# FAIRFAX COUNTY

## STAFF REPORT

APPLICATION RZ/FDP 2003-PR-022  
(concurrent with SEA 82-P-032-5 and 8625-WPFM-001-1)

**APPLICANT:** Pulte Home Corporation

**DETAIL AREA #3**  
TOWN CENTER PLAZA DETAIL

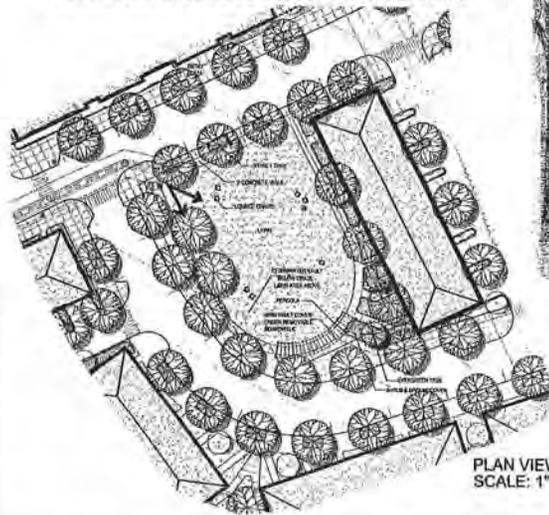
used for outdoor performances, ice skating and other activities (see Detail #3 on Sheet 13). It should be noted that there will be no direct vehicular connection between Saintsbury Drive and the remainder of the development; the other portion of the site will only be accessible from Vaden Drive Extended.

**DETAIL AREA #7**

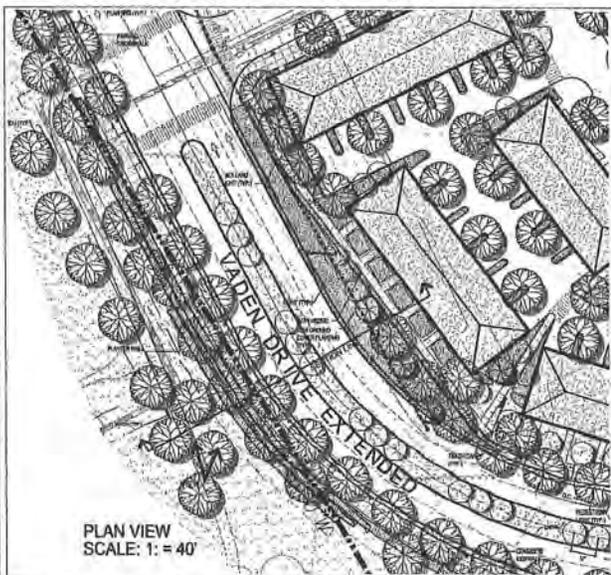
- *Trees along both sides of the realigned portion of the City of Fairfax Connector Trail.* Detail #7 on Sheet 14 indicates that trees will be planted along both sides of the realigned portion of the City of Fairfax Connector Trail.
